# Preliminary Consultation MONTGOMERY COUNTY HISTORIC PRESERVATION COMMISSION STAFF REPORT

Address: 518 Philadelphia Avenue, Takoma Park Meeting Date: 3/6/2024

Review: Preliminary Consultation Staff: Chris Berger

**PROPOSAL:** Partial demolition, building addition, fenestration alteration, deck construction.

Figure 7: The proposed front elevation shows how the rear addition will appear from the right of way.

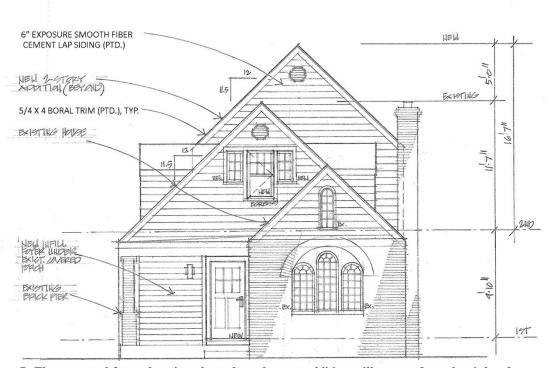
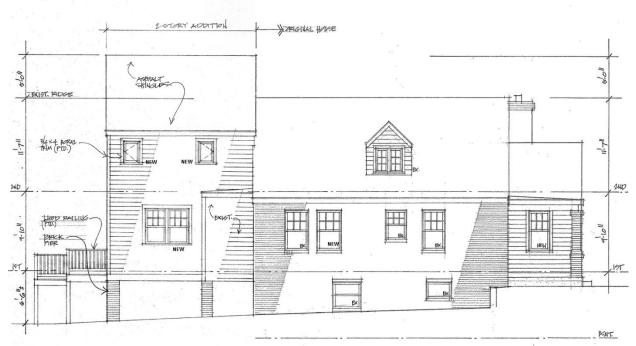
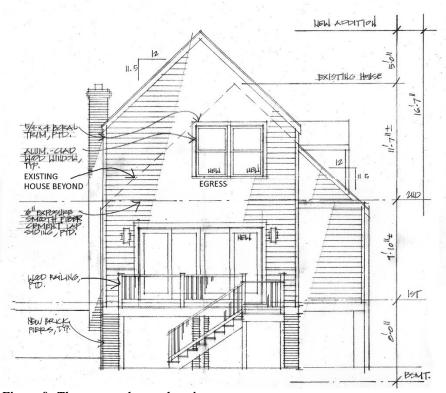
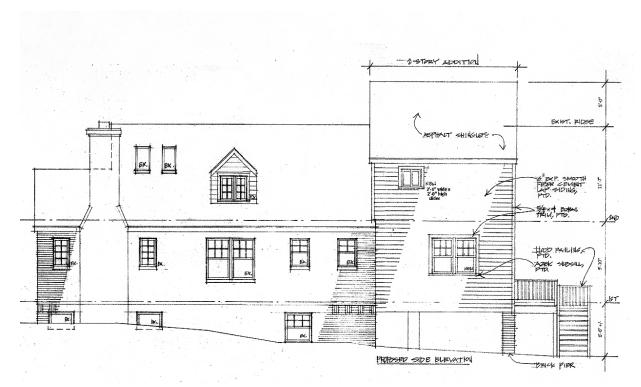
The fiber cement lap siding is a compatible material for the building, which has lap siding in the upper gables. Staff encourages the applicant to match the 8-inch exposure of the existing siding as opposed to the proposed 6-inch siding. Staff recommends the applicant consider additional windows on the right-side elevation to break up the massing. Currently, there is a pair of 6/1 sash windows on the first floor, and two sliding windows on the second floor. Staff also recommends the applicant inset the addition at least 1-foot on the right-side elevation to differentiate the existing construction from the proposed. (It appears on the left-side elevation that a small section of the existing rear elevation will be retained.) Any new HVAC equipment should be shown on the site plan and elevations.

- 1. Existing condition or as-built drawings for all elevations.
- 2. Roof plan.
- 3. Inset the addition at least 1-foot on the right-side elevations.
- 4. Lap siding exposure should match the existing.

- 12. Add additional windows on the right-side elevation to break up the massing.
- 13. Move the existing front door to the exterior wall of the proposed enclosed porch.

Figure 12: The proposed enclosed porch is clouded in red.

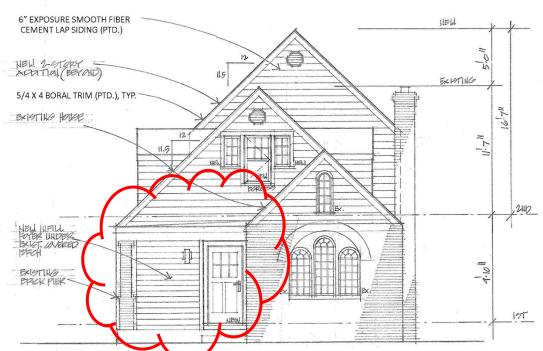
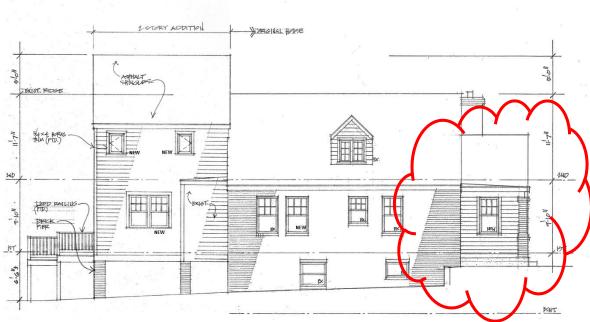
Staff recommends that a window or windows similar in size and appearance are added to the front elevation of the infilled area to break up the massing. Staff also recommends that the existing front door, inset in the front porch, is moved to the exterior wall of the proposed enclosed area.

Figure 14: The existing window, left, will be replaced and two casement windows will be installed to either side.

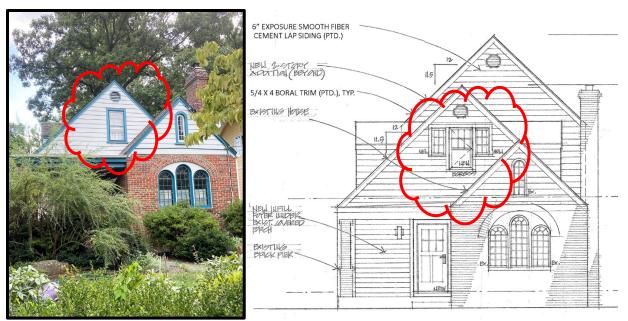
Staff recommends that the muntins of the windows are either true-divided lite or simulated divided lite with permanent exterior and interior grilles.

- 10. Include location of new HVAC equipment on plans.
- 11. The aluminum clad window grilles shall be either full divided lite or simulated divided lite with permanent exterior and interior grilles.
